5.0 Reactor Coolant System and Connection Systems

5.1 Summary Description

The information in this section of the reference ABWR DCD, including all subsections and figures, is incorporated by reference with the following departures.

Figure 5.1-1 Rated Operating Conditions of the ABWR

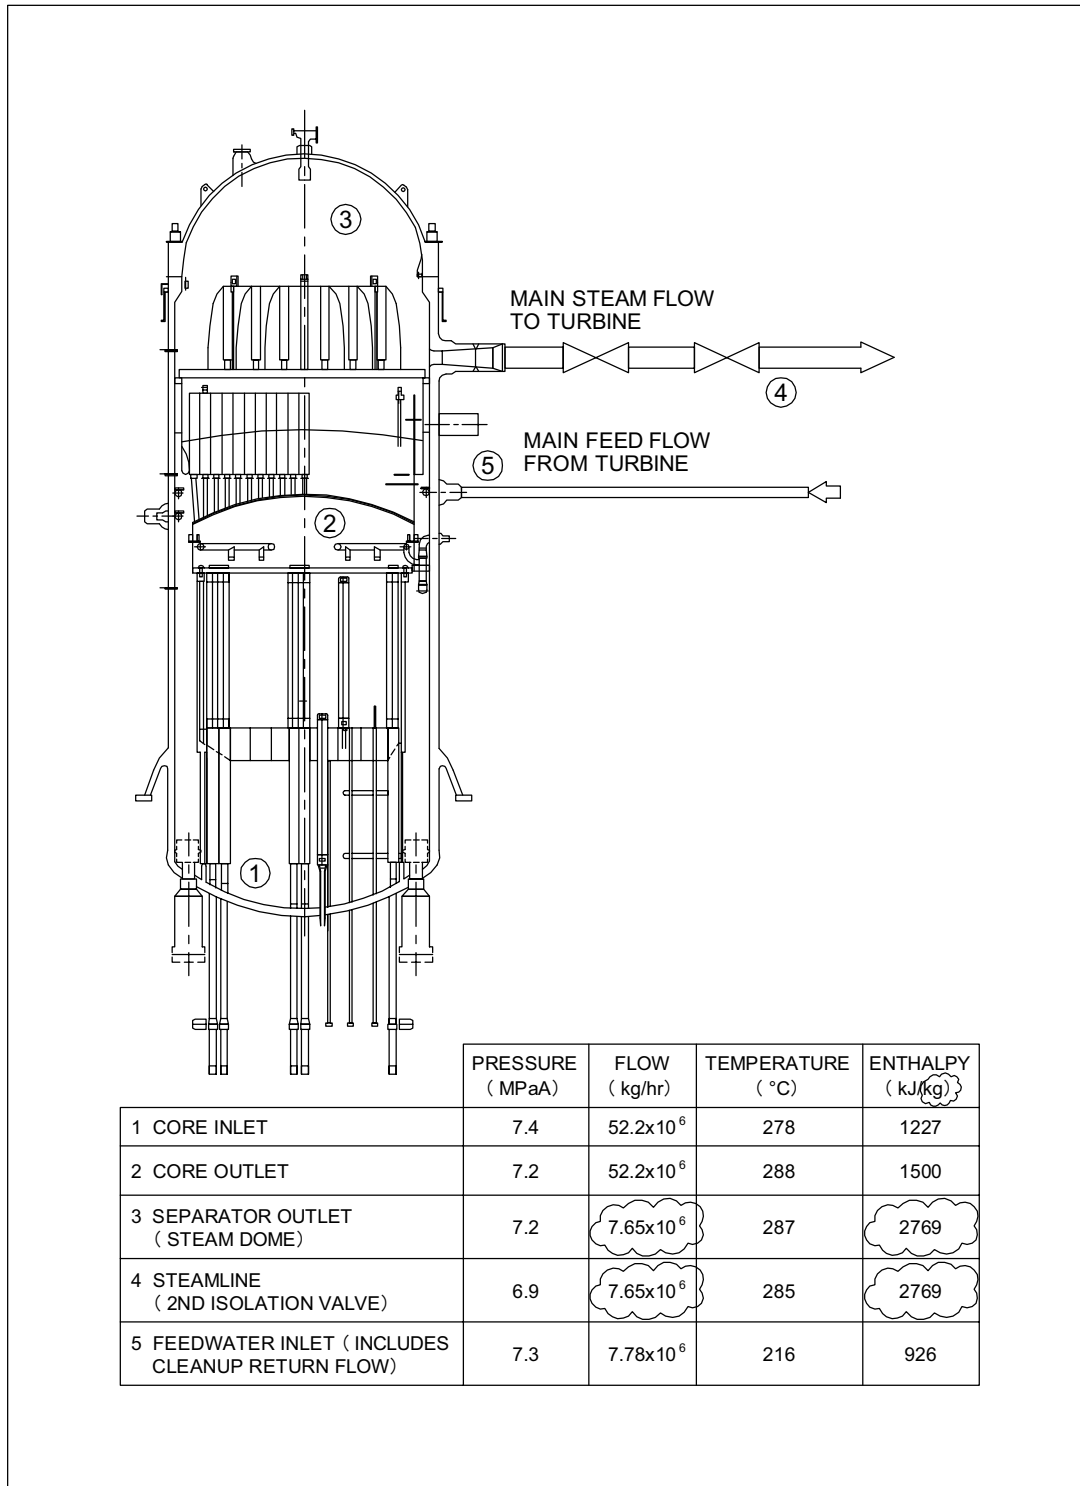
STP DEP 10.1-3 (Figure 5.1-1)
